ANT-39000

Encoder

FRONT CASE

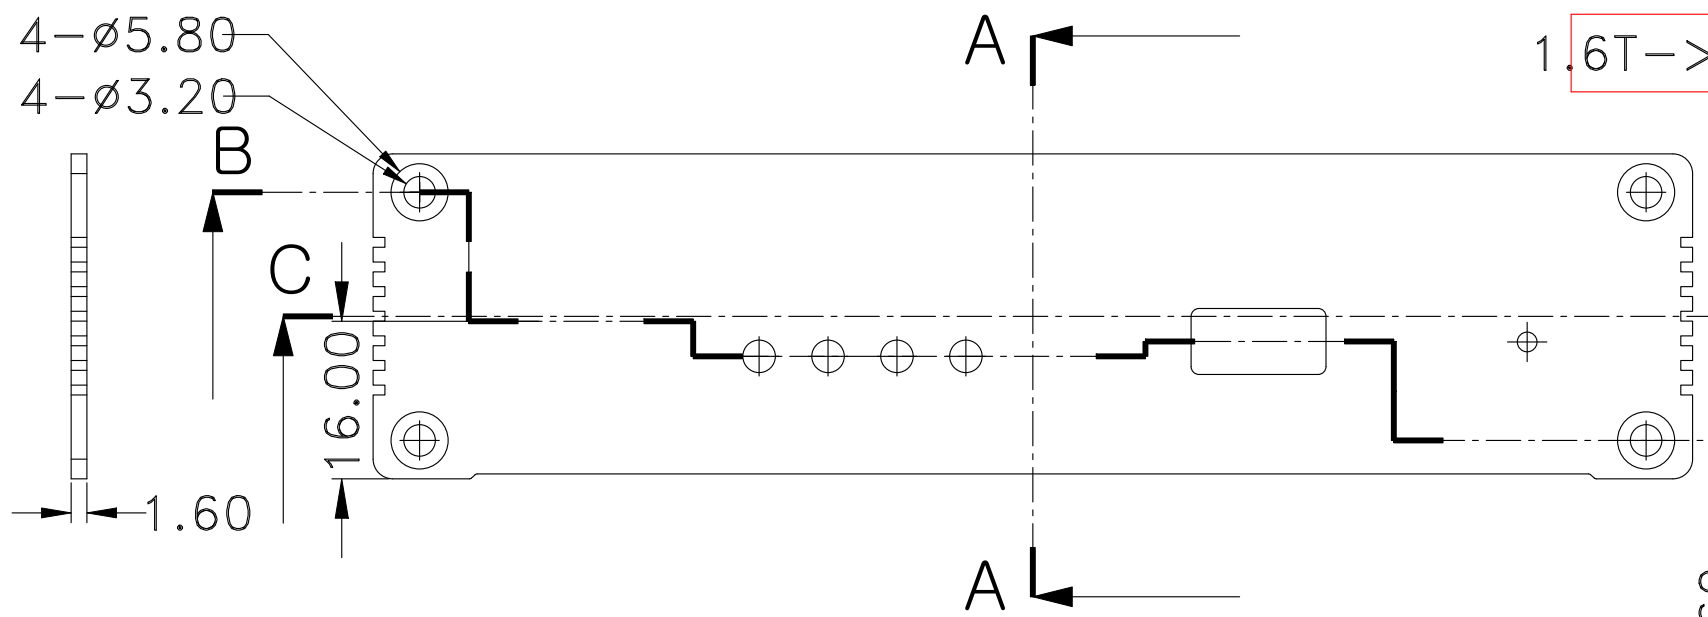
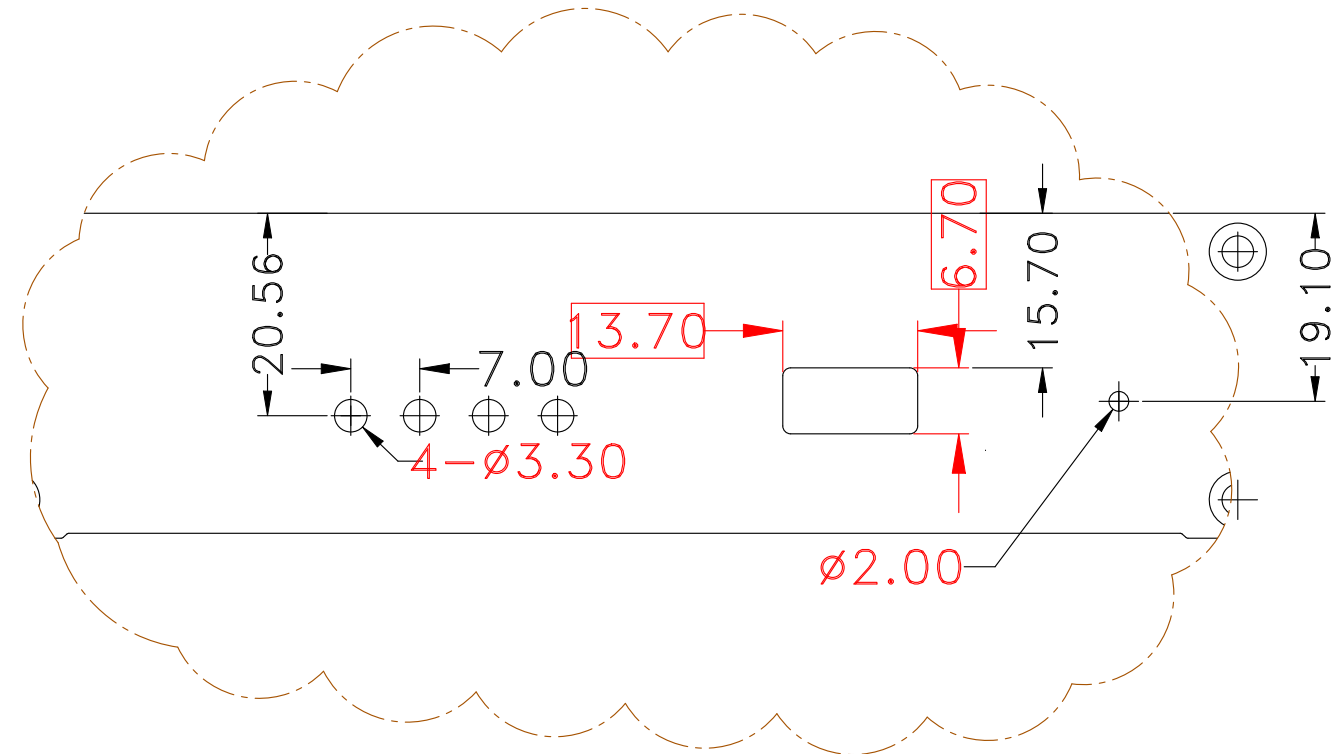
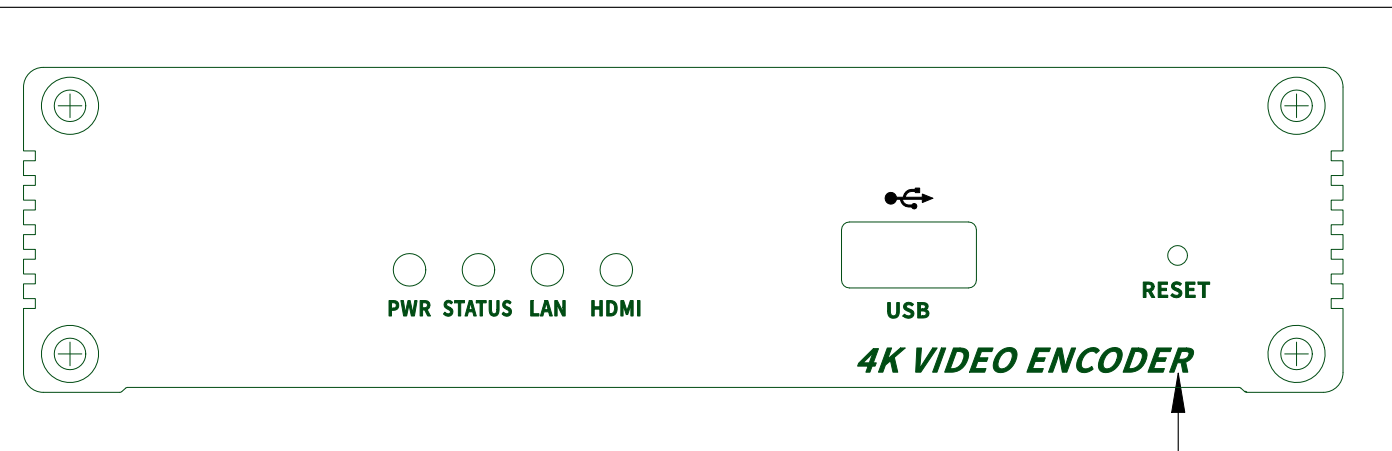
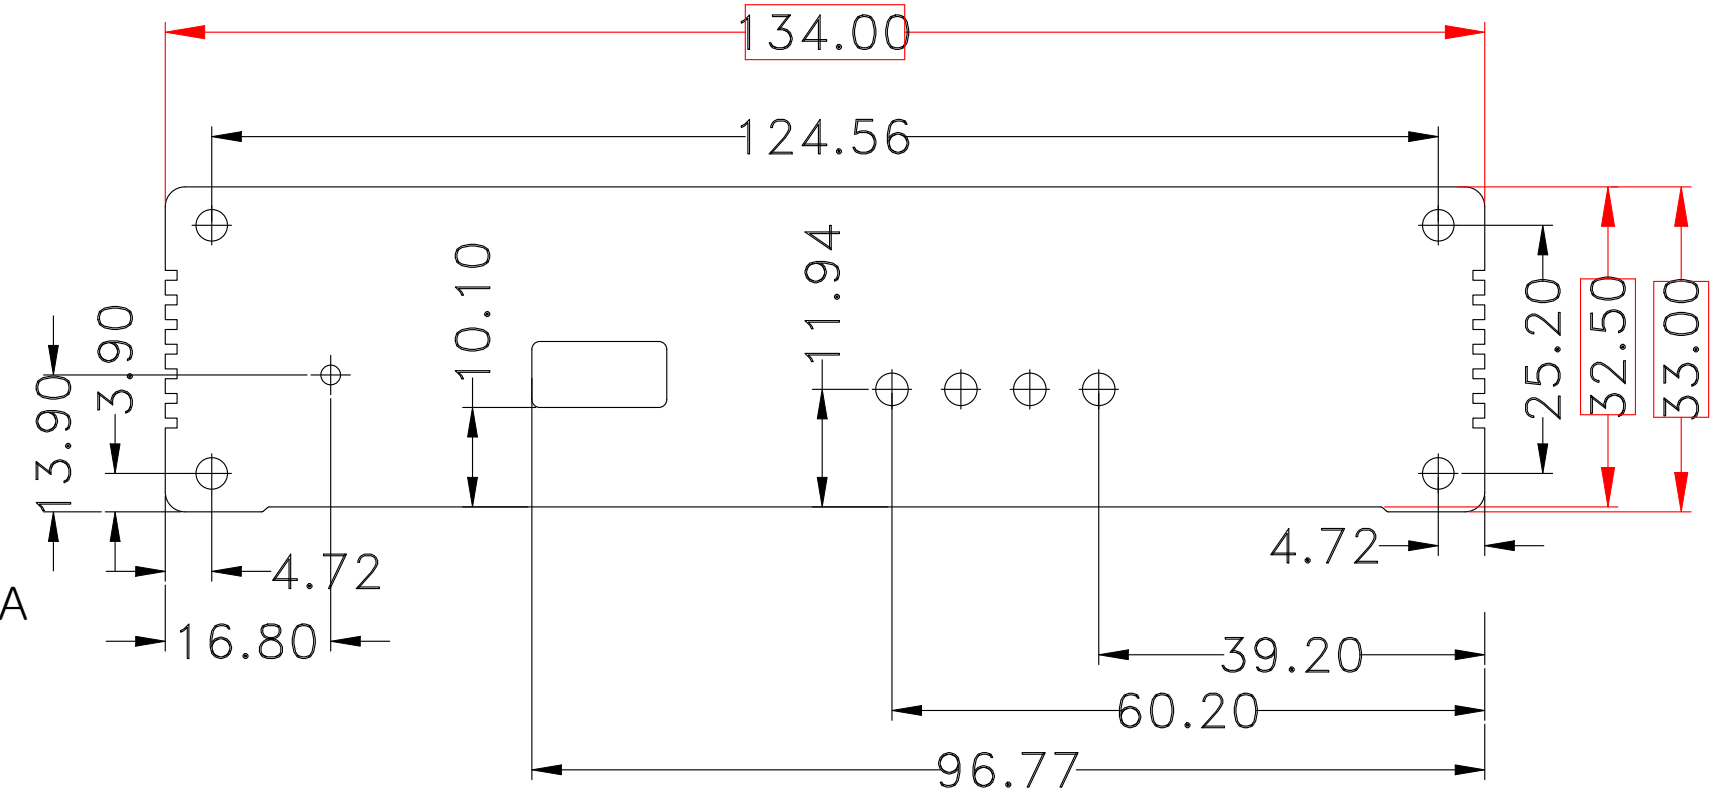
22.07.29 USB 사이즈 및 위치 변경
(아래로 0.4mm 이동)

22.08.10. 홀 5개소 위치 변경
(아래로 0.4mm 이동)

MARK	REASONABLE REVISIONS	REV. DATE	SIGN
1	DECODER 문구 FRONT로 이동(기존 REAR 공용)	22.07.05	YU.J.I
2	PCB 두께 1.6T=>1.2T(두께 변경 건 확인 오류, 개발초기 미정), 회로 단자들 PCB 두께만큼 0.4mm 내림-아래로 이동)	22.08.10	-
3	-	-	-
4	바탕 BLACK, 문자 WHITE 사양 추가	2022. 11. 15	J. I. YU
